VEHICLE RECALL

**G-03508
May 2003**

**SUBJECT: SAFETY RECALL (U.S., EXPORT)
Tail Pipe Exhaust Single Band Clamp on 9000 Series
Models built 11/15/2002 through 3/12/2003 with
Caterpillar Engines.**

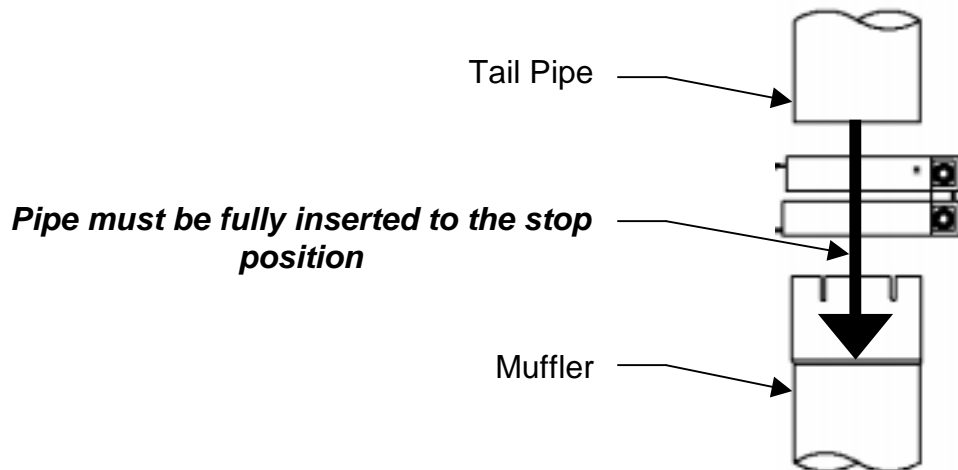
1. Remove Single Band Clamp.
2. Note the correct orientation of Double Band Clamp:

- Tail pipe side stamped "PIPE"

- Muffler side has no stamp

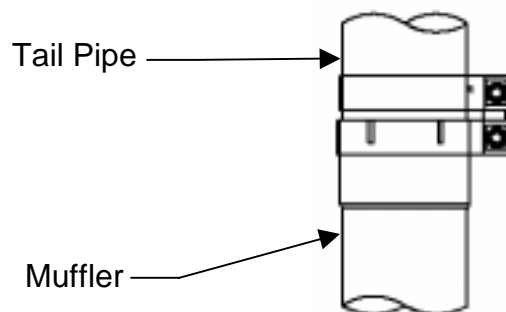
3. Slide double band clamp onto tail pipe.
 - ***Do not spread double band clamp to install -- Slide down over top of tail pipe to install.***
 - If clamp will not slide over top of tail pipe, remove tail pipe.
4. If tail pipe was removed, pre-install clamp onto tail pipe. DO NOT TIGHTEN clamp bolts. If pipe was not removed, skip to number 5.
5. Ensure tail pipe is fully inserted into muffler opening.

6. Slide double band clamp down so muffler side of clamp is positioned as noted:
 - ***Lower clamp is positioned over muffler tip and top clamp is positioned over the tail pipe.***

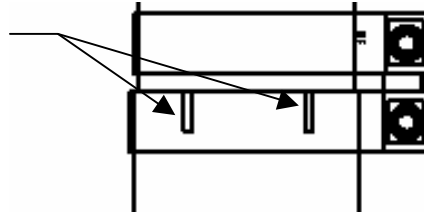
9. Position muffler side clamp flush with top edge of muffler discharge.

Muffler Clamp must cover all slots completely to avoid a loose joint or leaks.

10. Torque both clamp bolts to **27-37 lb-ft** (37-50 N-m).
